**AGENDA
CITY OF CEDAR FALLS, IOWA
PLANNING AND ZONING COMMISSION MEETING
WEDNESDAY, MAY 22, 2019
5:30 PM AT CITY HALL**

TO: Planning & Zoning Commission
FROM: Shane Graham, Economic Development Coordinator
DATE: May 16, 2019
SUBJECT: Highway-1 District Site Plan Review

TO: Planning & Zoning Commission
FROM: David Sturch, Planner III
DATE: May 14, 2019
SUBJECT: College Hill Neighborhood Site Plan Review – 2119 College Street

LOT 2 GATEWAY BUSINESS PARK DEVELOPMENT SITE PLAN

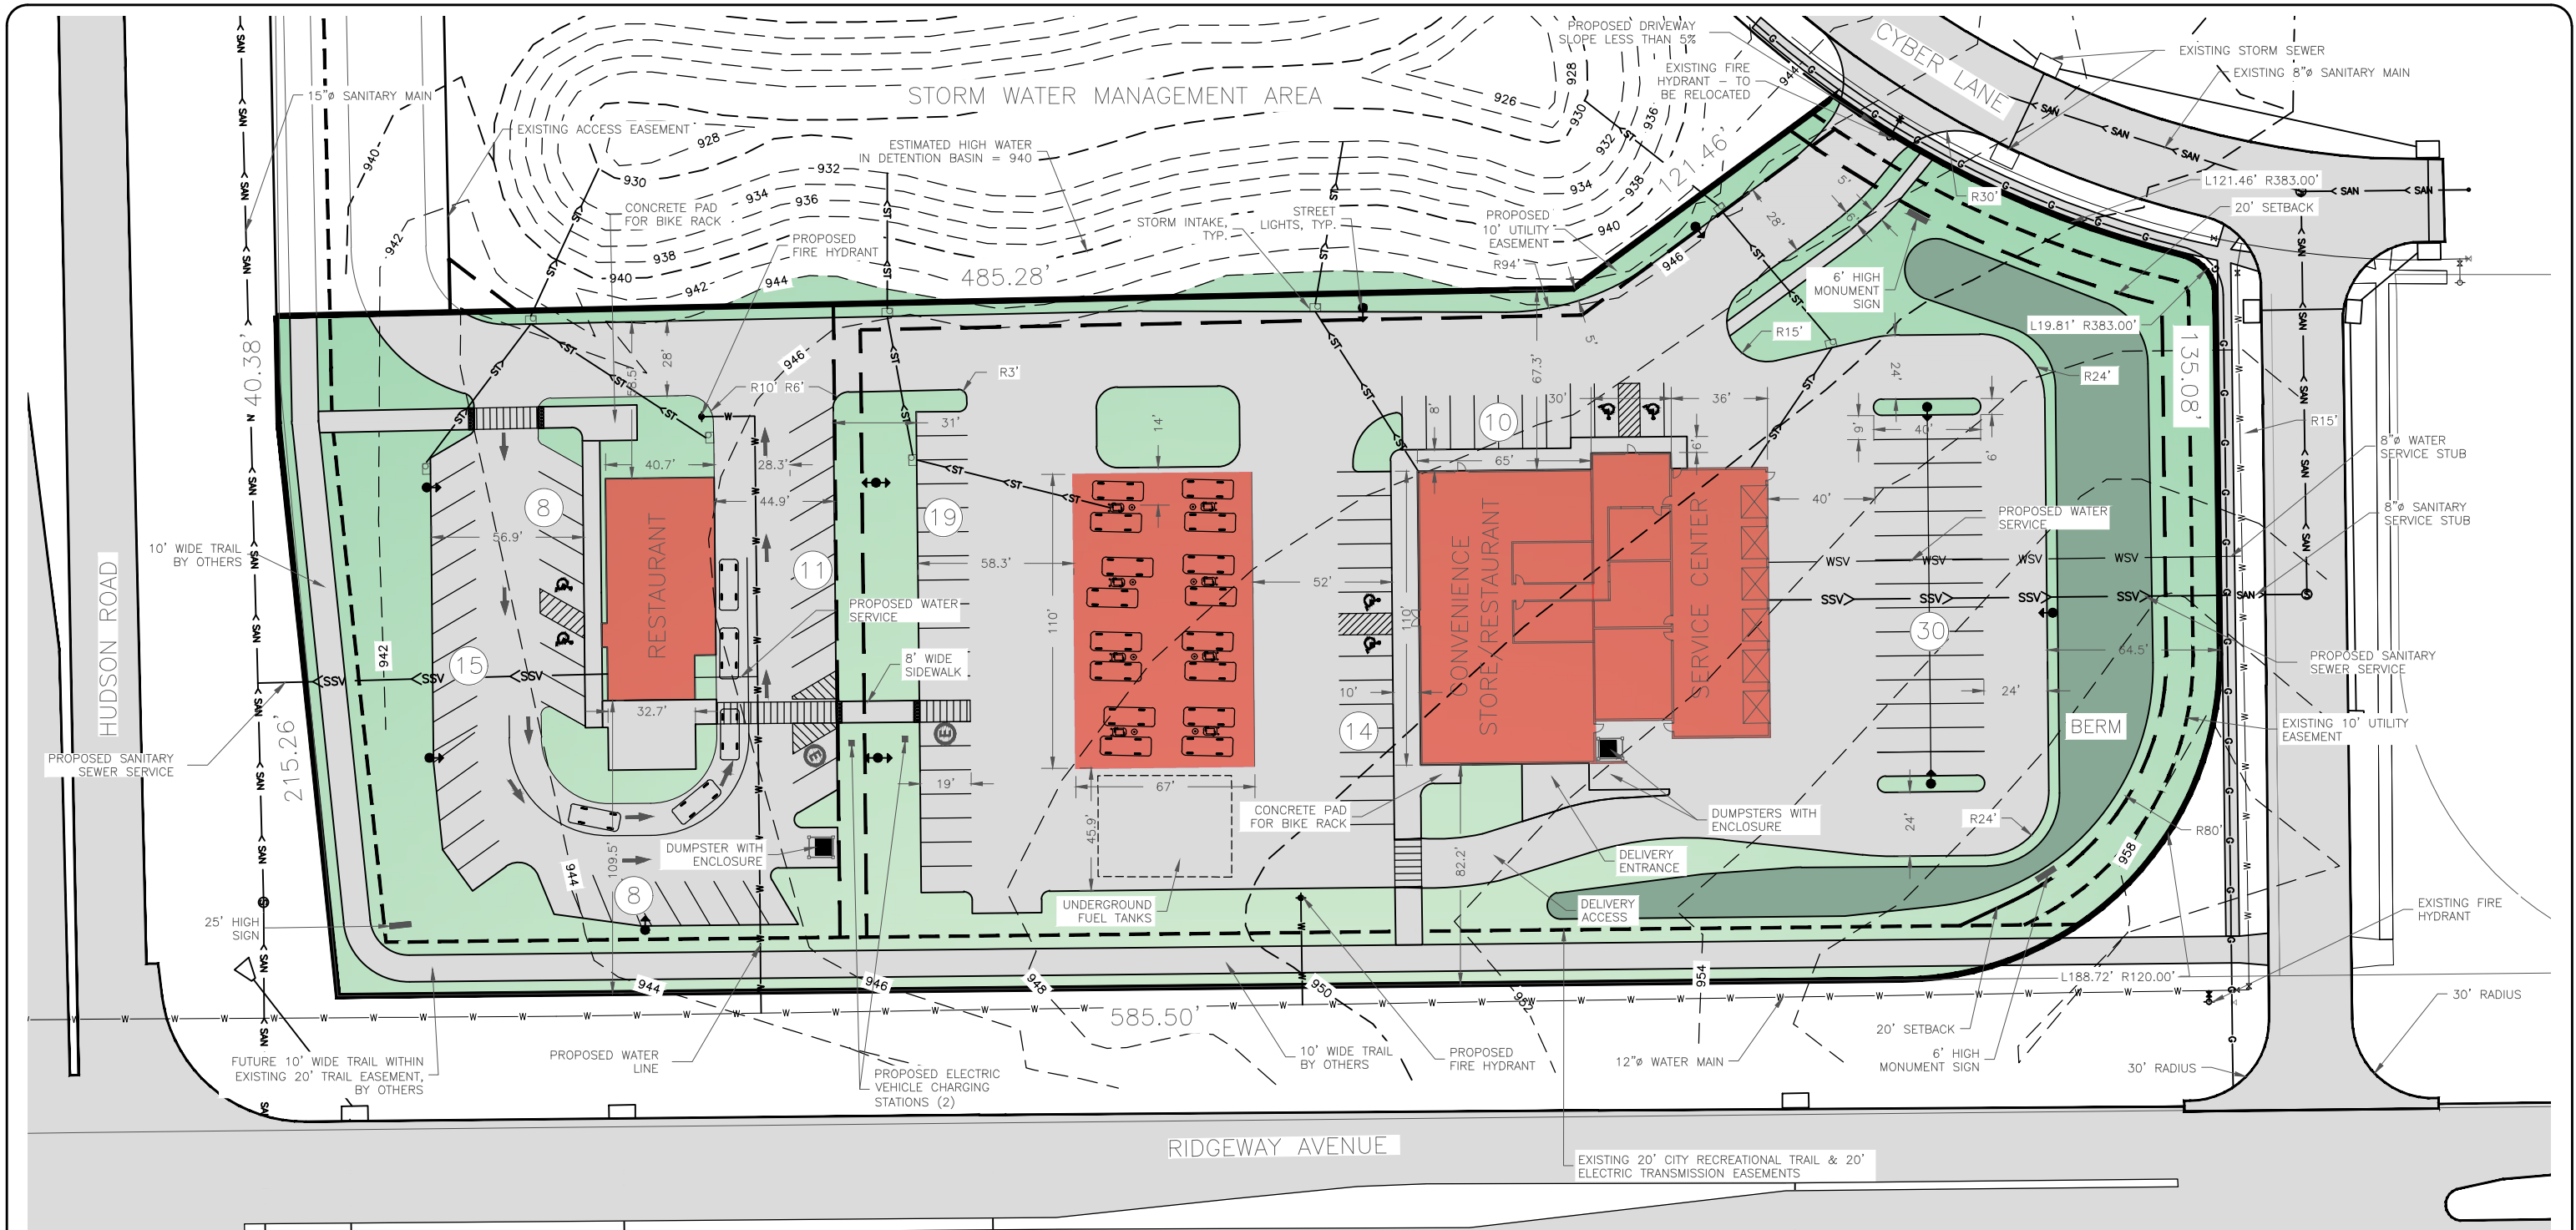
The main area in front of the convenience store/gas station near the gas canopy does appear to have a large quantity of concrete, as there is 39' from the parking area at the west end of the site to the gas canopy, and 42' from the parking lane in front of the building to the gas canopy. Staff had previously questioned if the pavement area could be reduced, but the developer indicated at the previous Planning & Zoning Commission meeting that the area is needed for maneuvering of larger vehicles or vehicles that tow boats or trailers. In addition, the underground gasoline storage tanks are located to the south of the gas canopy, so area is needed for trucks to deliver the fuel.

Jon Biederman, Civil Engineer for the project, stated that they have additional parking spaces as they believe they will need them. He also addressed the additional pavement around the gas canopy, noting that many times people will have larger vehicles or trailers that will need the extra room to maneuver. He also discussed parking and open space requirements, as they would like to replace a small green space near the northwest corner of the convenience store building with pavement.

Mr. Larson felt it made sense to leave the additional pavement and he was okay with the cornice and the removal of the islands.

Mr. Wingert also noted that he believes that the cornice is good as it is, and that he understands the need for the additional paving.

North
Planting Plan
 SCALE: 1" = 50'

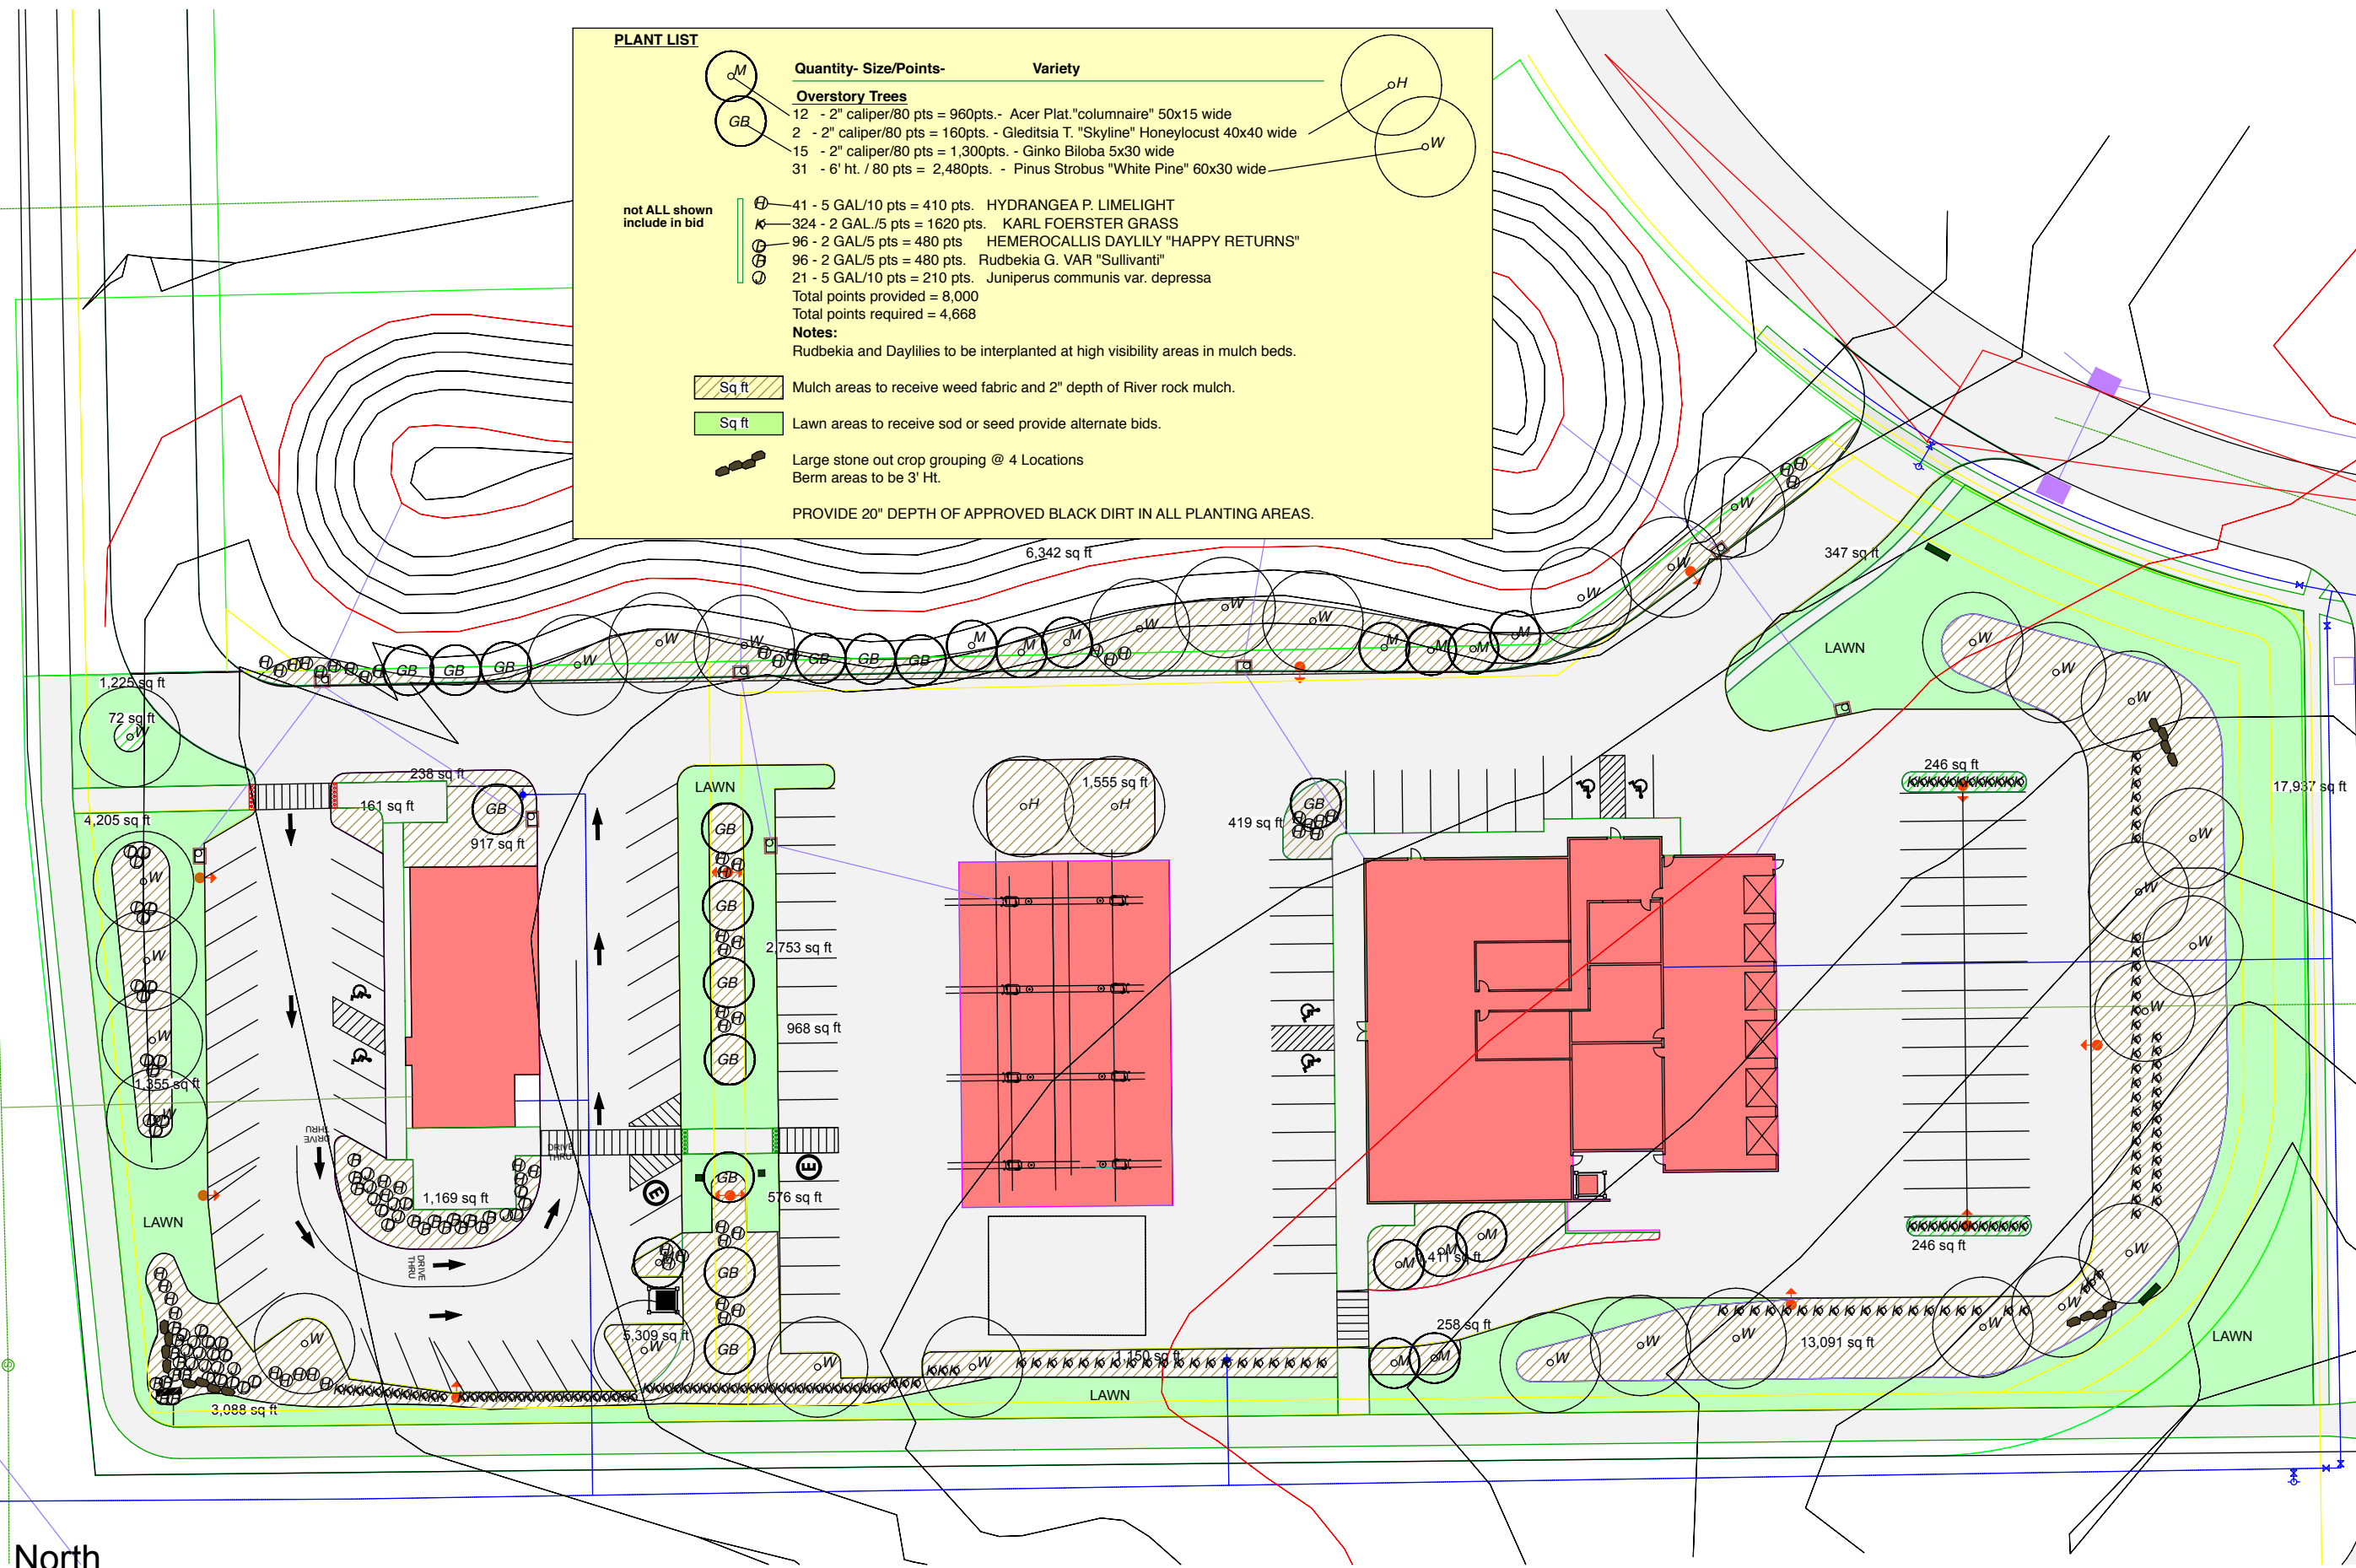
At the previous Planning & Zoning Commission meeting, the applicant indicated that they would like to remove an open greenspace area located near the northwest corner of the convenience store building due to concerns about maintenance (see area circled in the image to the right). The image to the right is a portion of the landscape plan, and this area does show a tree with several shrubs. This area is also shown with river rock mulch instead of grass. Staff would request that this area be left as is per the landscape plan, as it does provide a nice landscape area that divides the parking area on the north side of the building and the west side of the building, and does not have grass, which should allow for easier maintenance.

GROUND LEVEL PARKING PLAN

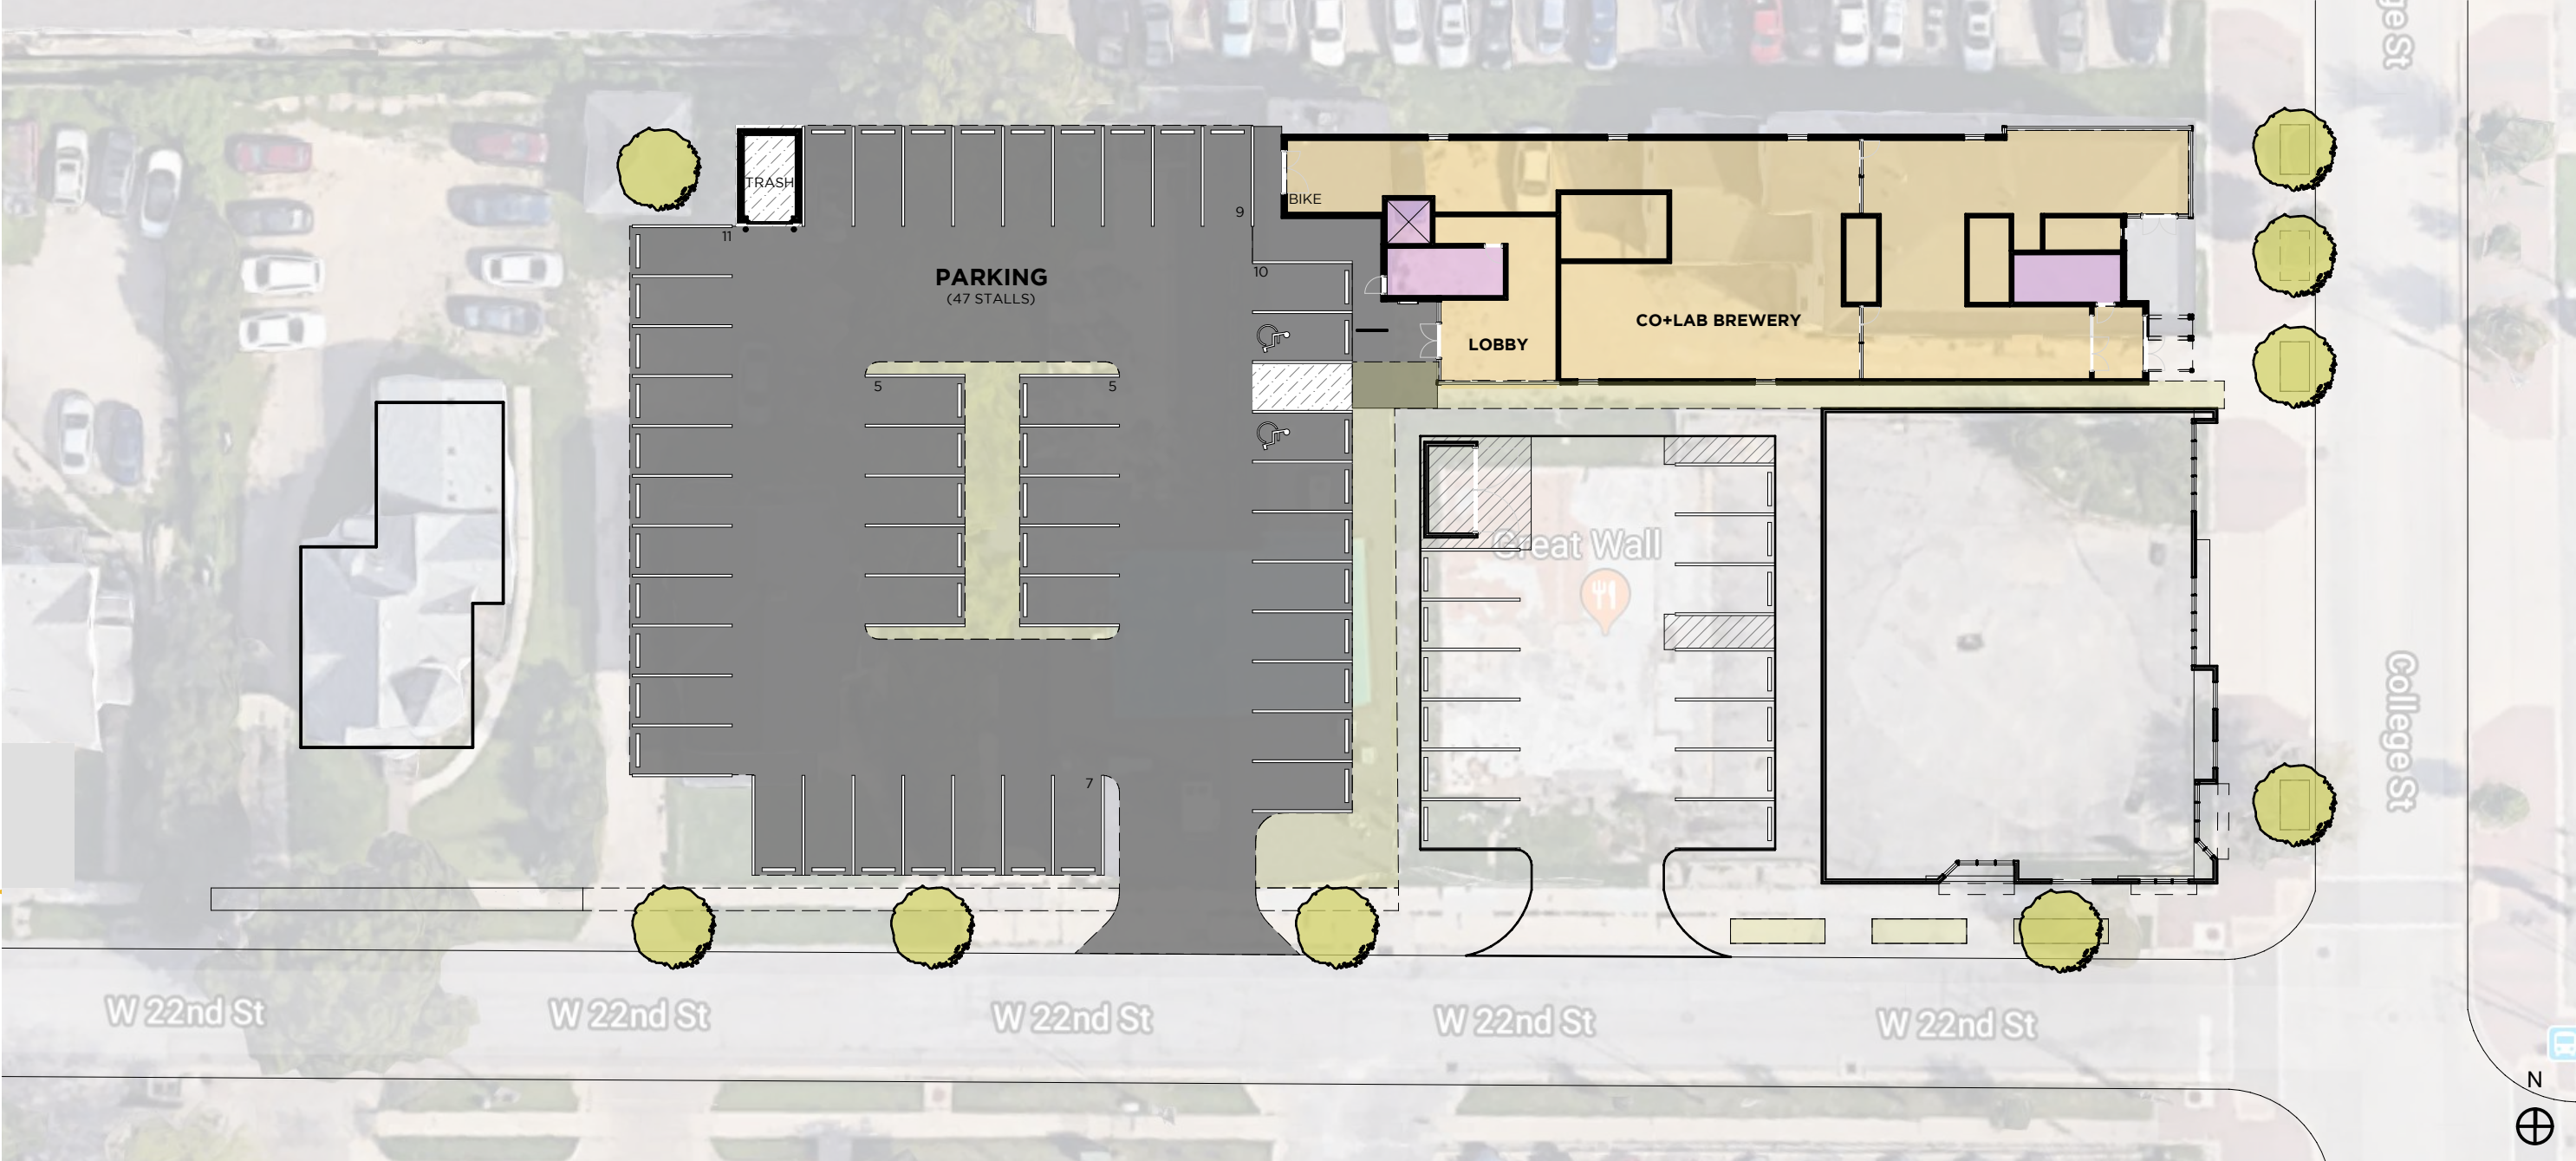
The background on this issue is well known. This revised site plan for 2119 College Street is quite different than previous plans submitted for this lot. However, the plan still suffers from the fatal flaws contained in all prior plans—violation of the Code of Cedar Falls regarding parking. While the building size has decreased, the applicant has also reduced parking. Prior site plans provided 48% of parking required by Code. The current plan provides 62% of required parking.

Under Ordinance §§ 29-177(a)(12B) & 29-160(e)(1)(c) this building requires: 46 spaces for the 23 studio units; 8 spaces for the 4 two-bedroom units; 16 spaces for the 4 four-bedroom units; and at least 5 visitor spaces. This totals 75 required spots, yet only 47 are provided. Prior site plans included one level of underground parking, which could provide some of these missing spots, yet the applicants have eliminated all underground parking from the current plan.
